UNITED STATES PATENT AND TRADEMARK OFFICE

Office Action Summary	Application No. 10/550,247	Applicant(s) CHALVIGNAC, PHILIPPE
	Examiner ARUNDIPTA SHOME	Art Unit 3771

DETAILED ACTION

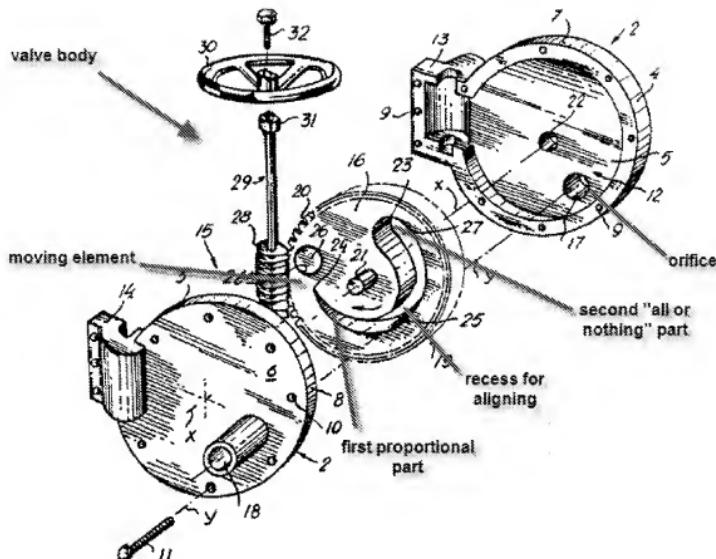
Regarding Claim 7, Chalvignac's inhalation valve 16 inherently has an orifice connected to the inhalation duct. This valve is a balloon valve, so it also appears to be operable to block the orifice in a closed position and partially free the orifice in an open position. However, Chalvignac does not disclose the valve comprising a recess for aligning with the orifice with the recess having a first part with a proportional operation and a second part with an all or nothing operation. Torres teaches a valve with a recess for aligning with the orifice with the recess having a first part with a proportional operation and a second part with an all or nothing operation, as shown below. It would have been obvious to one of ordinary skill in the art at the time the invention was made to substitute Chalvignac's inhalation valve with the valve as taught by Torres because both valve structures were well known in the art and substituting one valve for another would work equally well.

Regarding Claim 8, Torres's valve has the recess is shaped so that when the moving element moves from the closed position to the open position, the first part is aligned with the orifice, and the second part is aligned with the orifice if the movement continues (clockwise motion in the figure above).

Regarding Claim 9, the first part of the recess show above is triangular at the tip. The second part of the recess is not rectangular. However, it would have been obvious to one of ordinary skill in the art at the time the invention was made to modify the shape to be rectangular.

The base of the triangle of the first part shown above would be parallel to one of the sides of the rectangular end of the recess shown above.
